Access Compliance Report

Public Rights-of-Way

(Curb Ramps)

Intersection ID: 7330	Main Street: HEATHERBROOKE_AV	Cross Street: PONDELLA_DR	Location: SW
ADA ID: 0BAEF6D8AE6A	Ramp Type: Perp	Initial Pass/Fail: Fail	Overall Compliance: No
Severity Score: 21.25			
Codes/Mitigation Info/Possible Solution		Field Measurements/Component Compliance

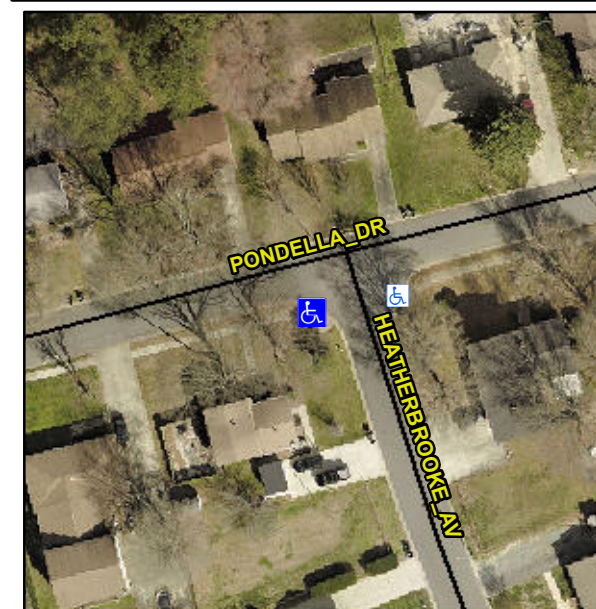
Not Found, R304.5.1, R304.2.2

Compliance	Description	Data	Compliance	Description	Data
N/A	Ramp Length (in)	48.0	No	Ramp Slope (%)	8.4
No	Ramp Width (in)	38.0	Yes	Ramp XSlope (%)	1.4
N/A	Flare Type LT	N/A	N/A	Flare Type RT	N/A
N/A	Flare Slope LT (%)	N/A	N/A	Flare Slope RT (%)	N/A
N/A	Flare Traversable LT?	N/A	N/A	Flare Traversable RT?	N/A
N/A	Landing Length (in)	N/A	N/A	DWS Provided?	N/A
N/A	Landing Width (in)	N/A	N/A	DWS Contrast?	N/A
N/A	Landing Slope (%)	N/A	N/A	DWS Length (in)	N/A
N/A	Landing X Slope (%)	N/A	N/A	DWS Full Width?	N/A
N/A	Landing Curb? (Y/N)	N/A	N/A	DWS Offset (in)	N/A
N/A	Shared Landing?	N/A			
N/A	Gutter Ponding?	N/A	N/A	Gutter Slope (%)	N/A
N/A	Gutter Lip Ht (in)	N/A	N/A	Gutter X Slope (%)	N/A
N/A	Painted X Walk1?	No	N/A	Painted X Walk2?	N/A
	X Walk 1 Direction	To E		X Walk 2 Direction	N/A
N/A	X Walk 1 Width (in)	N/A	N/A	X Walk 2 Width (in)	N/A
	X Walk 1 Slope (%)	4.4		X Walk 2 Slope (%)	N/A
	X Walk 1 X Slope (%)	0.4		X Walk 2 X Slope (%)	N/A

Remove & Replace Entire Ramp.
